Access Compliance Report

Public Rights-of-Way

(Curb Ramps)

Intersection ID: 31686	Main Street: GALLISON_AV	Cross Street: SNOWDROP_DR	Location: SW
ADA ID: 1D4D8B4DC825	Ramp Type: PerpDiag	Initial Pass/Fail: Fail	Overall Compliance: No
		Severity Score: 10

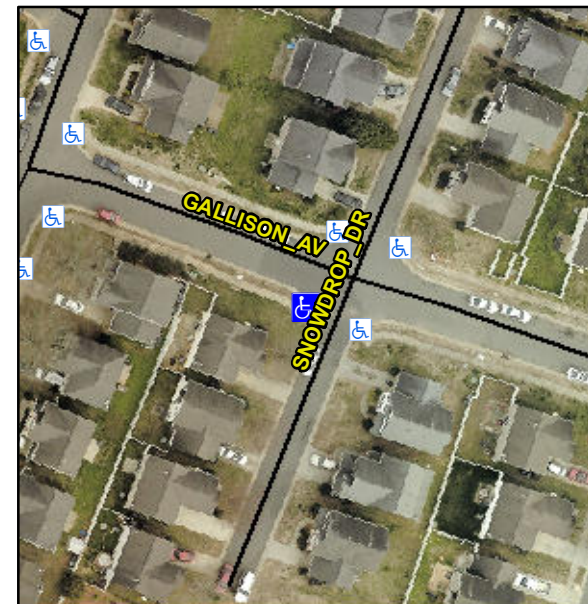
R304.5.1, R304.5.3

Compliance	Description	Data	Compliance	Description	Data
N/A	Ramp Length (in)	47.0	Yes	Ramp Slope (%)	7.2
No	Ramp Width (in)	37.0	No	Ramp XSlope (%)	2.2
N/A	Flare Type LT	N/A	N/A	Flare Type RT	N/A
N/A	Flare Slope LT (%)	N/A	N/A	Flare Slope RT (%)	N/A
N/A	Flare Traversable LT?	N/A	N/A	Flare Traversable RT?	N/A
N/A	Landing Length (in)	N/A	N/A	DWS Provided?	N/A
N/A	Landing Width (in)	N/A	N/A	DWS Contrast?	N/A
N/A	Landing Slope (%)	N/A	N/A	DWS Length (in)	N/A
N/A	Landing X Slope (%)	N/A	N/A	DWS Full Width?	N/A
N/A	Landing Curb? (Y/N)	N/A	N/A	DWS Offset (in)	N/A
N/A	Shared Landing?	N/A			
N/A	Gutter Ponding?	N/A	N/A	Gutter Slope (%)	N/A
N/A	Gutter Lip Ht (in)	N/A	N/A	Gutter X Slope (%)	N/A
N/A	Painted X Walk1?	No	N/A	Painted X Walk2?	No
	X Walk 1 Direction	To SE		X Walk 2 Direction	To NE
N/A	X Walk 1 Width (in)	N/A	N/A	X Walk 2 Width (in)	N/A
	X Walk 1 Slope (%)	0.9		X Walk 2 Slope (%)	0.4
	X Walk 1 X Slope (%)	2.1		X Walk 2 X Slope (%)	1.1

Remove & Replace Curb Ramp With Two New Directional Ramps or Equivalent.
